**Invitation for Bids for Construction of Belden Trail – Phase III for the
City of Brownsville**

CBT-12-0219

Addendum # 3

**City of Brownsville
Purchasing Department
ADDENDUM # 3**

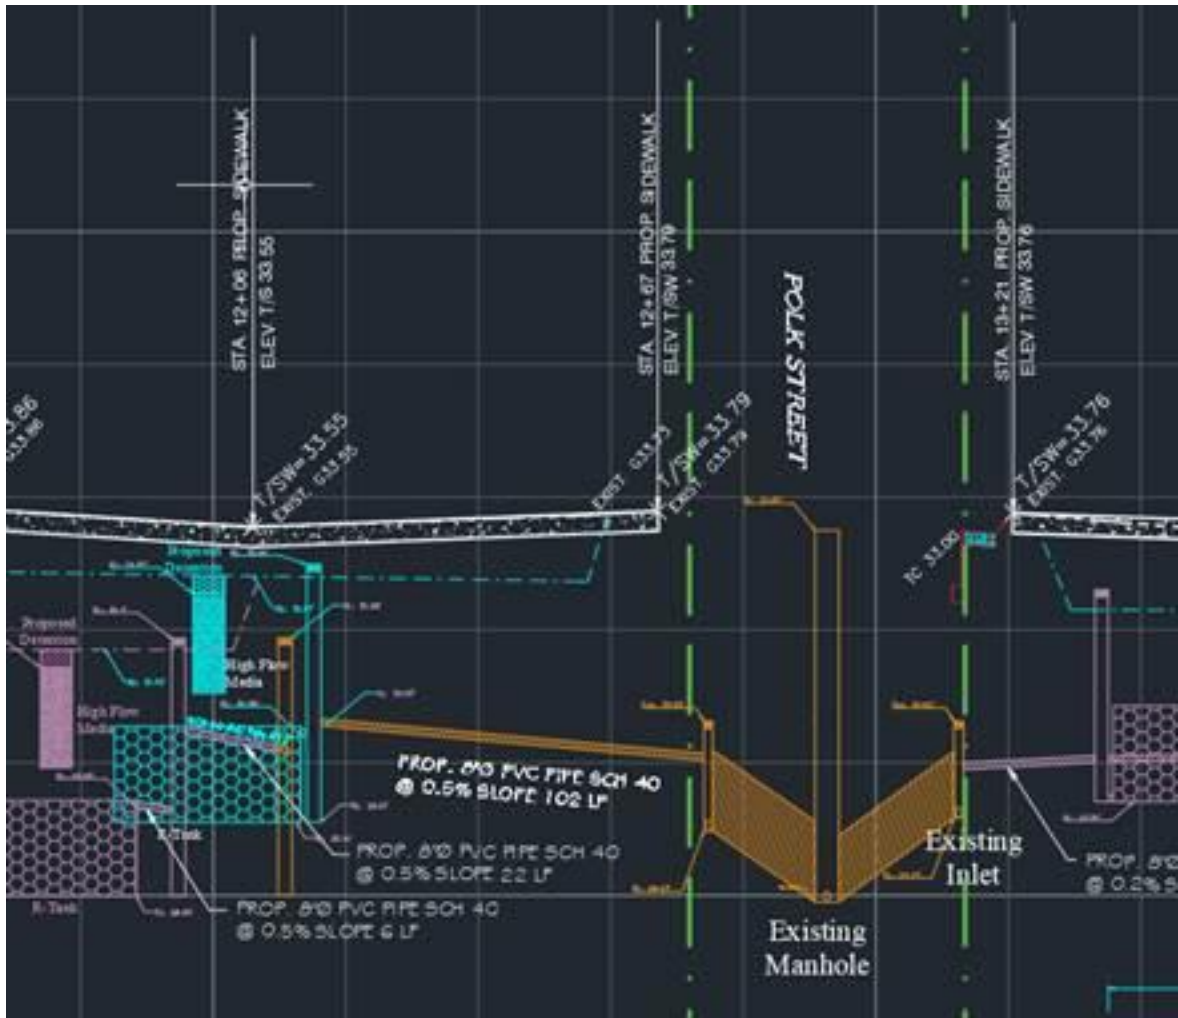
- Please clarify and identify what the 5(ea) **square and round structures** found on Plan sheet 1 are 3(ea) between Sta. 13+21 to Sta. 15+60 and the 2(ea) structures found on Plan Sheet 2 Sta. 20+40 and Sta. 21+20, (structures # 3,4,5,8 & 9).

Answer: Maintenance Ports called out on Detail R-Tank Typical Maintenance Port pg. 41

6 **1/2 HP SUMP PUMP AND CONCRETE BOX**
NTS

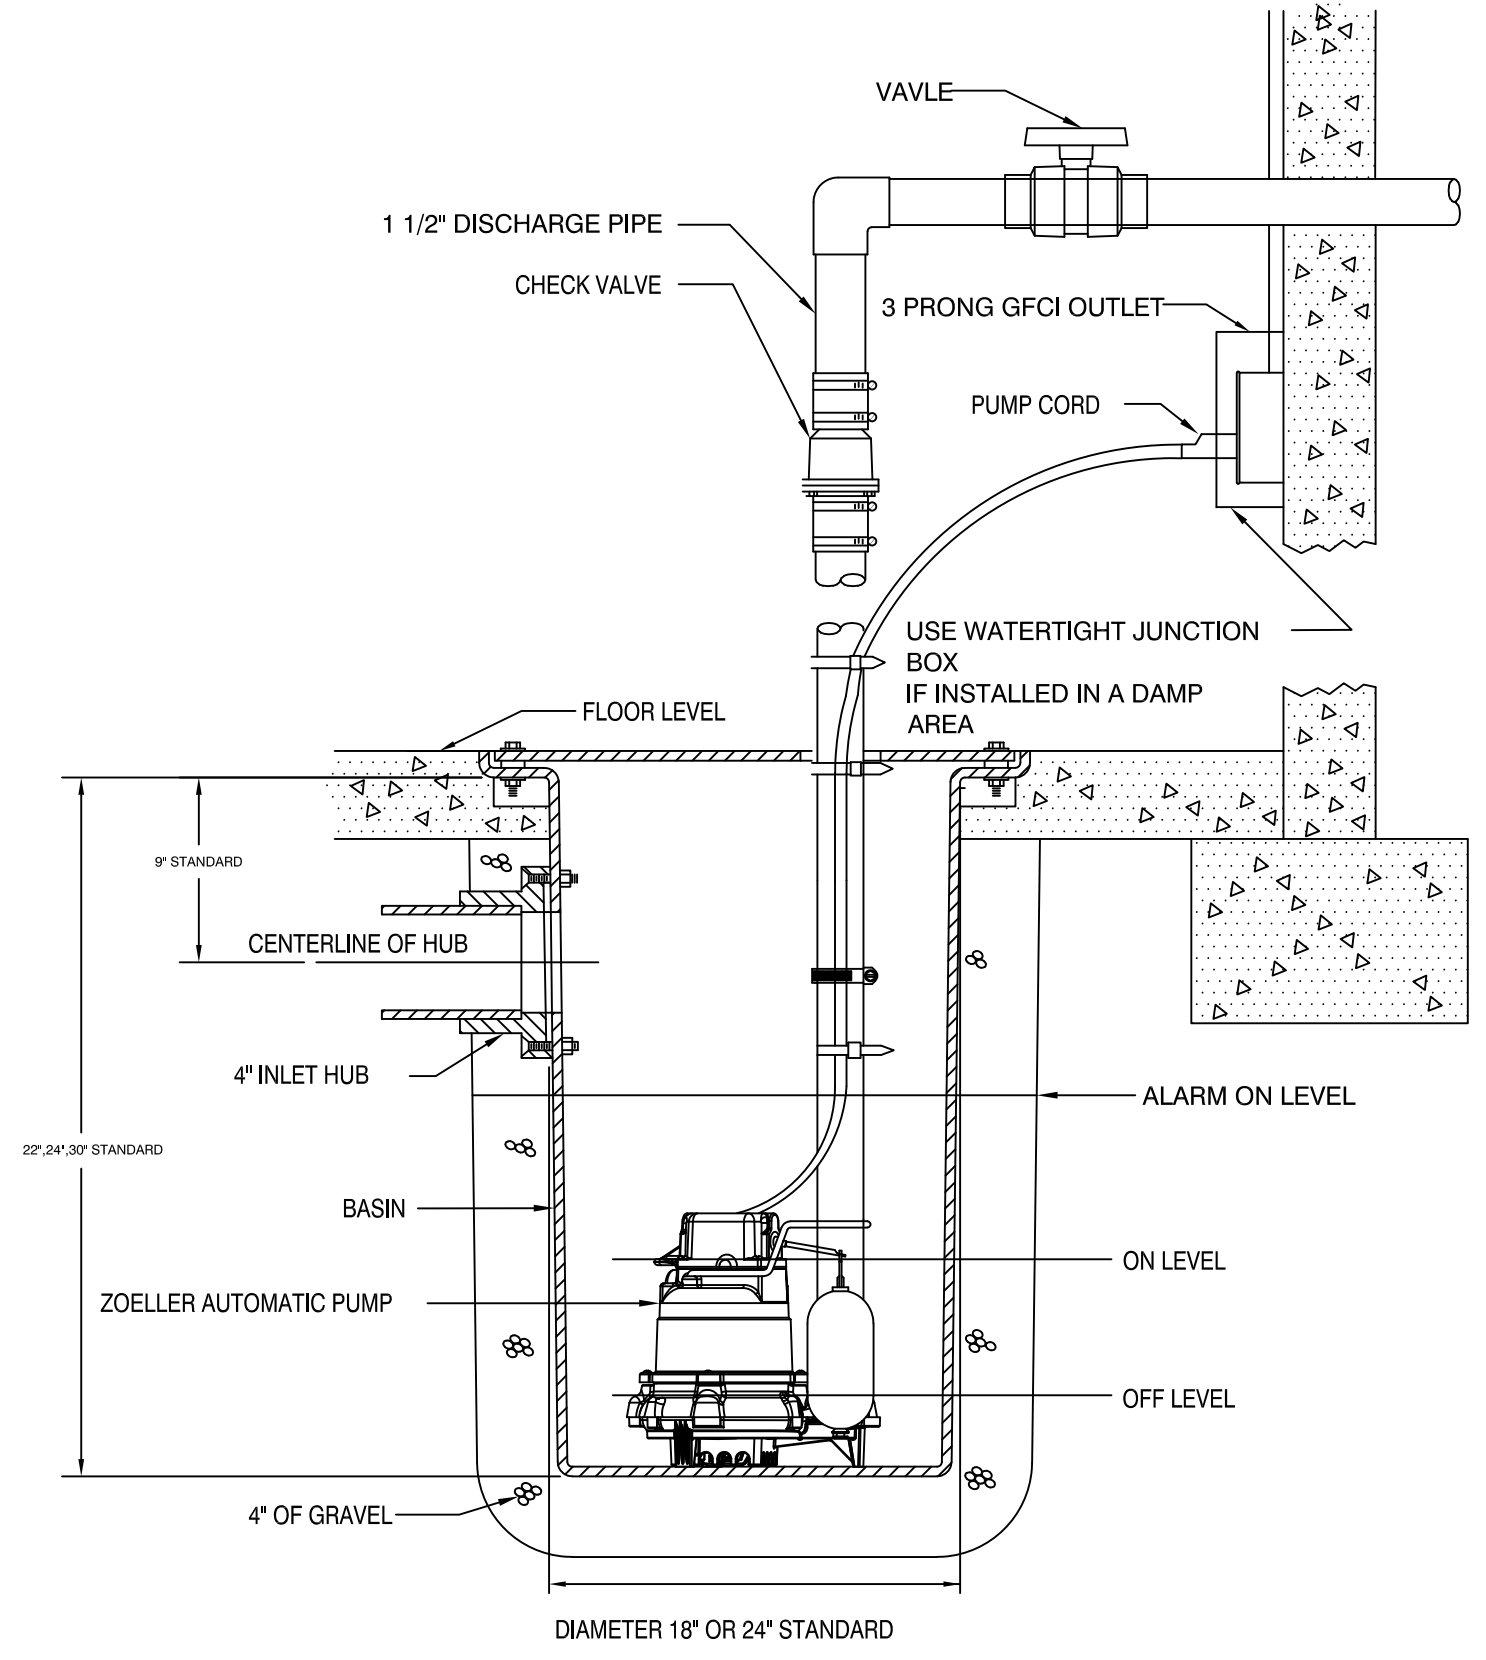
Please clarify what structure will the 1/2 HP Sump Pump be installed? There is no pay item in place for the structure or elevations.

Answer: Detail has been updated and attached ([Exhibit “B” ½ HP Sump Pump and Concrete Box](#)). ENG Line Item 6 – ½ HP Sump Pump; This item will be inclusive including all materials, labor, installation, in accordance with Plans
